Amendments to the Drawings

FIG. 1

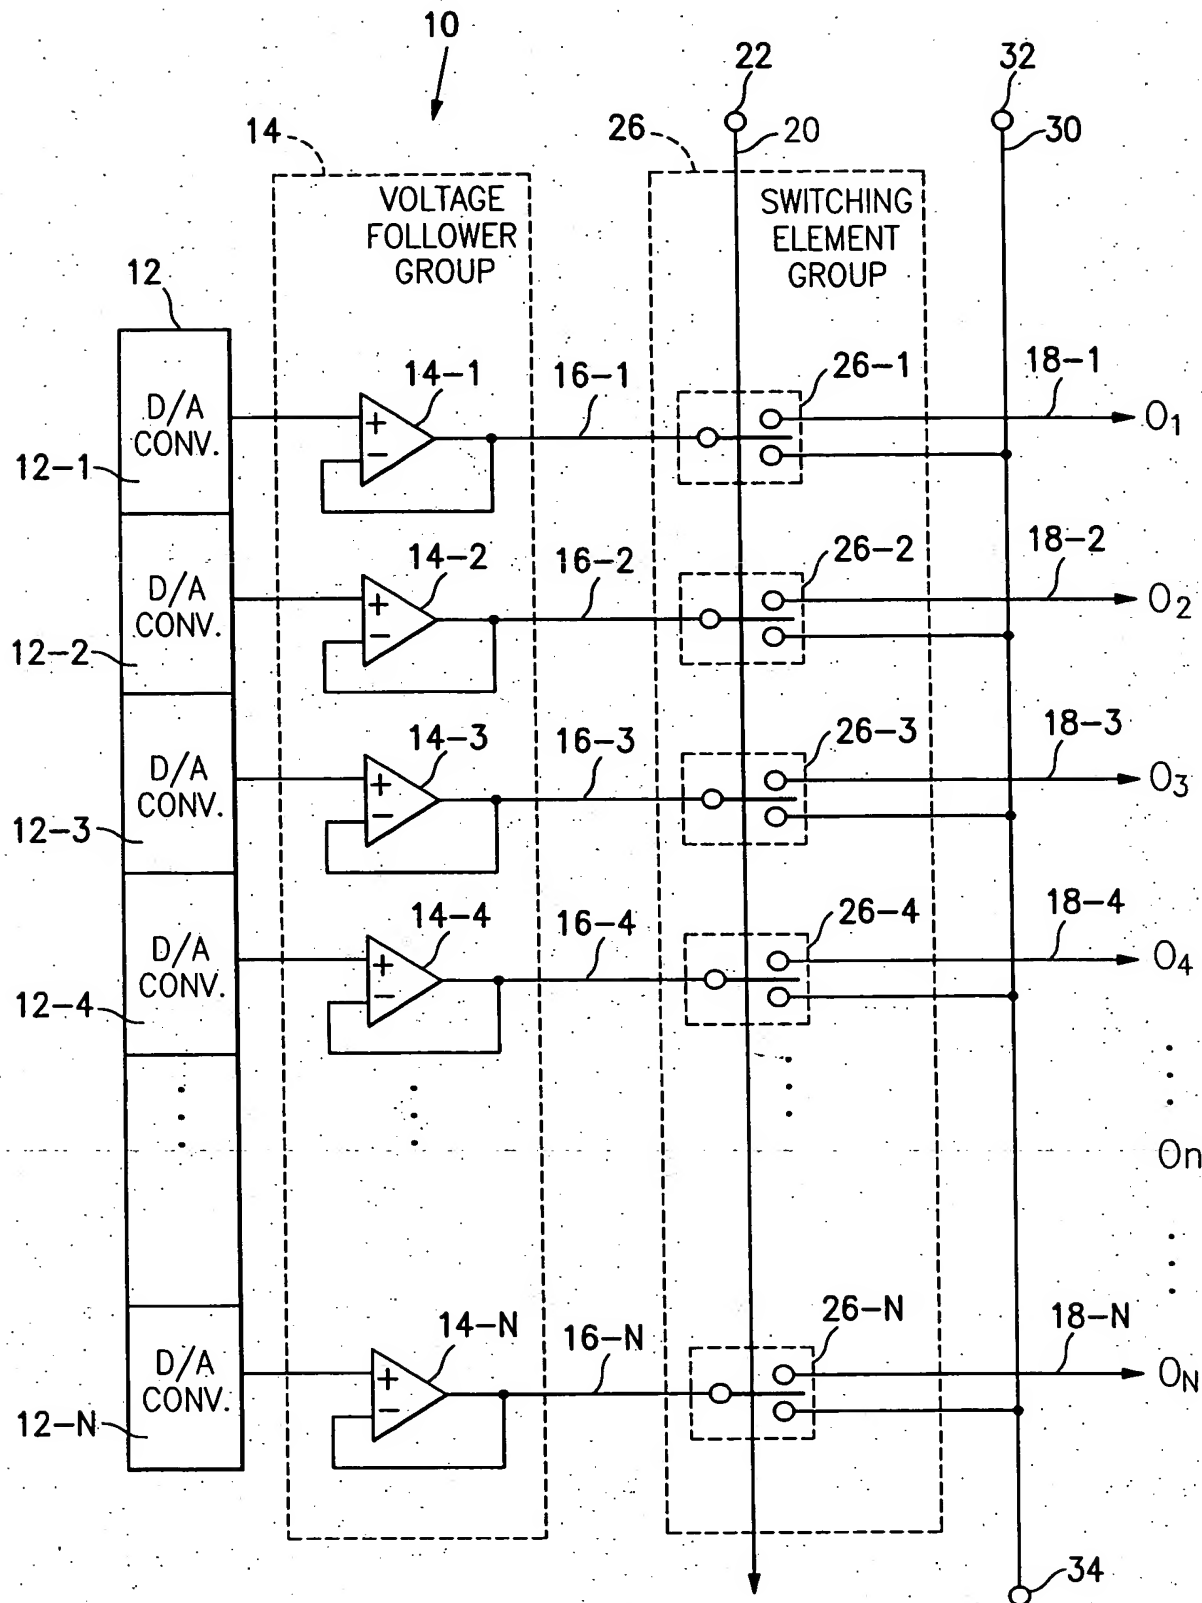
The attached four replacement sheets include changes to Figures 1 and 3-5. These sheets, which include Figures 1 and 3-5, replace the original drawing sheets including Figures 1 and 3-5. In Figures 1 and 3, boxes 12-1 through 12-N are labeled "D/A Conv.", box 14 is labeled "Voltage Follower Group" and box 26 is labeled "Switching Element Group". In Figure 4, box 52 is labeled "Signal Control Section". In Figure 5, box 72 is labeled "Input Latch Circuit".
